**PLANNED UNIT DEVELOPMENT
& SUBDIVISION STAFF REPORT****Date: September 6, 2012**

DEVELOPMENT NAME Schillinger Towne Centre Subdivision, Resubdivision of Lot 4

CONTEMPLATED USE Subdivision approval to create two legal lots of record from a legal lot of record and Planned Unit Development Approval to allow shared access and parking between multiple building sites.

SITE PLAN

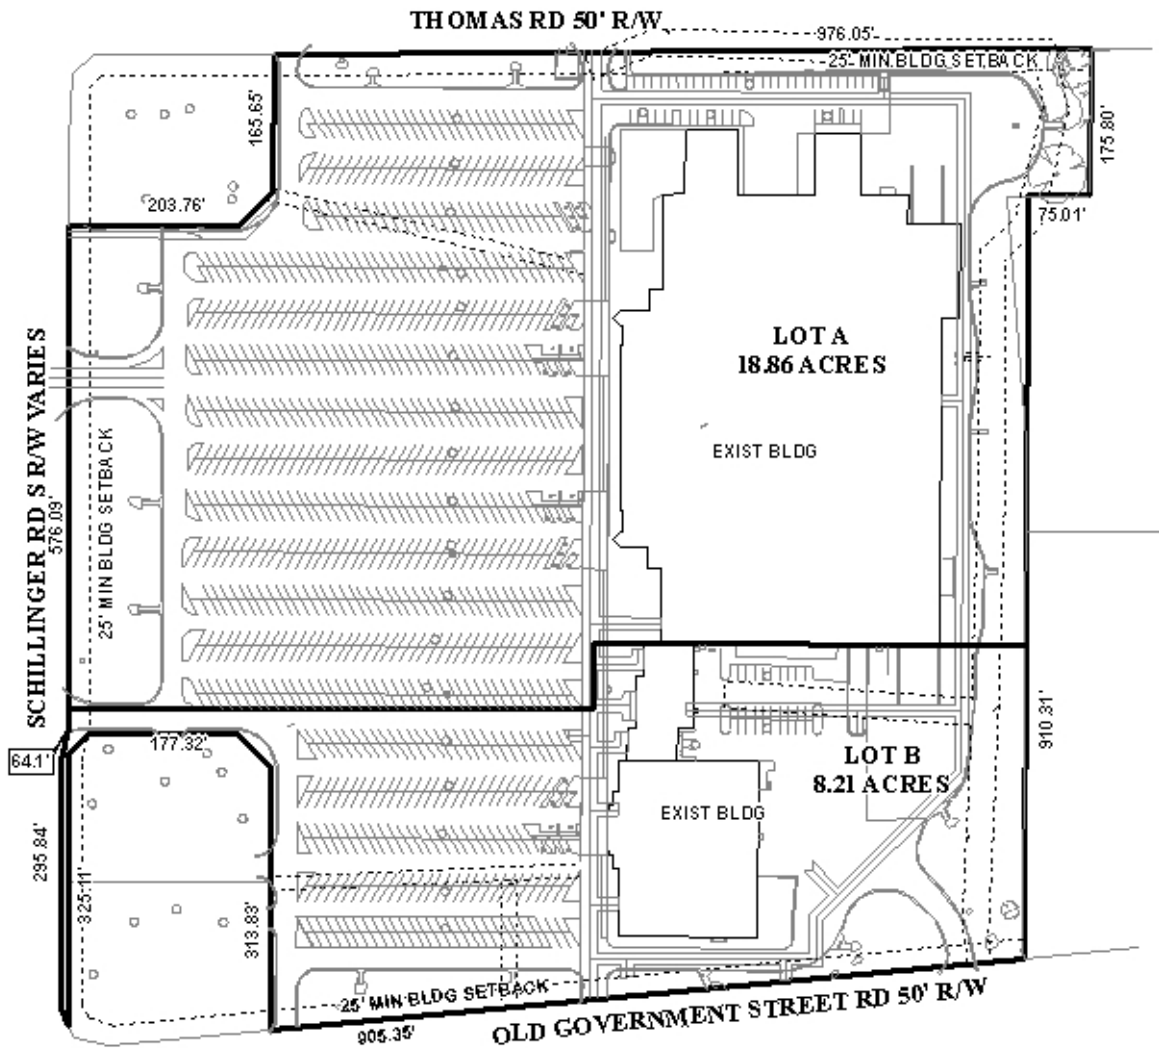
The proposed lots, as depicted, meet the minimum size and frontage requirements as regulated by the Subdivision Regulations. The 25-foot minimum building setback lines are depicted should be retained along ALL street frontages of all lots, if approved. The lot area sizes in square feet/acres are depicted on the preliminary plat, and this should be retained on the Final Plat, if approved.

As proposed, the interior lot line seems to bisect two existing structures at a common wall; therefore, the applicant should consult with the Building Code Official to comply with any building and/or fire codes.

The site fronts Schillinger Road South, a component of the Major Street Plan with a planned 100' right-of-way. As the preliminary plat illustrates Schillinger Road has a variable right-of-way along the site, dedication may be required. Therefore, the illustration of dedication sufficient right-of-way to provide 50-feet from the centerline of Schillinger Road South should be required. The site also has frontage along Thomas Road and Old Government Street Road, both minor streets with sufficient 50-feet rights-of-way.

The proposed Lot A, the northernmost lot provides four ingress/egress access points; two via Thomas Road (35-feet and 45-feet), one via Schillinger Road South (70-feet) and one internal via shared access to Lot 3, Schillinger Towne Centre Subdivision. Lot B provides six ingress/egress access points; three via Old Government Street Road (35-feet, 30-feet and 24-feet) one via Schillinger Road (30-feet), two internal via shared access to Lot 2, Schillinger Towne Centre Subdivision and one internal via shared access to Lot 1, Schillinger Towne Centre Subdivision. All drives are existing drives; therefore, no change to the circulation patterns to the public roads or internal circulation is proposed. As such, a note should be required on the Final Plat stating that the subdivision is limited to the existing curb cuts as stated in this paragraph, and if any changes to the existing curb cuts or if any new curb cuts are proposed, the size, design, and location must be approved by Traffic Engineering and conform to AASHTO standards. It should be noted that any changes or the creation of additional curb cuts may required a Traffic Impact Study.

City standard sidewalks are not indicated along Schillinger Road South, Thomas Road or Old Government Street Road; however, since this is a re-subdivision of a lot and no further development is proposed it would seem to be excessive to require sidewalks. The site plan does not indicate a dumpster or contain a note stating how trash pick-up is proposed. Therefore, the site plan should be revised to indicate a dumpster, in compliance with Section 64-4.D.9. of the Zoning Ordinance, and with a compliant sanitary sewer connection, or a note should be placed on the site plan stating that trash collection will be curb-side pick-up or private pick-up service.

As illustrated on the site plan, 1,326 parking spaces are provided for the development which is in a B-3, Community Business District; however, no building square-footage is illustrated. The revised site plan should indicate this in a table for future reference.

The site plan does not depict existing landscaping areas or tree plantings. Since the site was developed prior to annexation, full compliance with both landscaping area and tree plantings will not be required. However, frontage trees should be required for the site with the location to be coordinated with Urban Forestry. The site plan should be revised illustrating the square footage of landscaping and percentages of the total and frontage landscaping provided on proposed Lot A & B.

The site plan and preliminary plat do indicate a detention area. Since the detention area was required, it should be labeled as common area on both with a note stating that maintenance of the common area is the responsibility of the property owners.

- 1) illustration on the site plan the 25-feet minimum building setback line along all road frontages;
- 2) revision of the site plan to illustrate a 6-feet high wooden privacy fence along the rear (East) property line;

- 3) revision of the site plan to provide a dumpster, in compliance with Section 64-4.D.9. of the Zoning Ordinance, and with a compliant sanitary sewer connection, or the placement of a note on the site plan stating that trash collection will be curb-side or via private pick-up service;

- 4) revision of the site plan to depict compliance with frontage trees, to be coordinated with Urban Forestry and the square footage and percentages of total and frontage landscaping;

- 5) labeling of any required detention area as common area and the placement of a note on the site plan stating that the maintenance of the common area is the responsibility of the property owners;
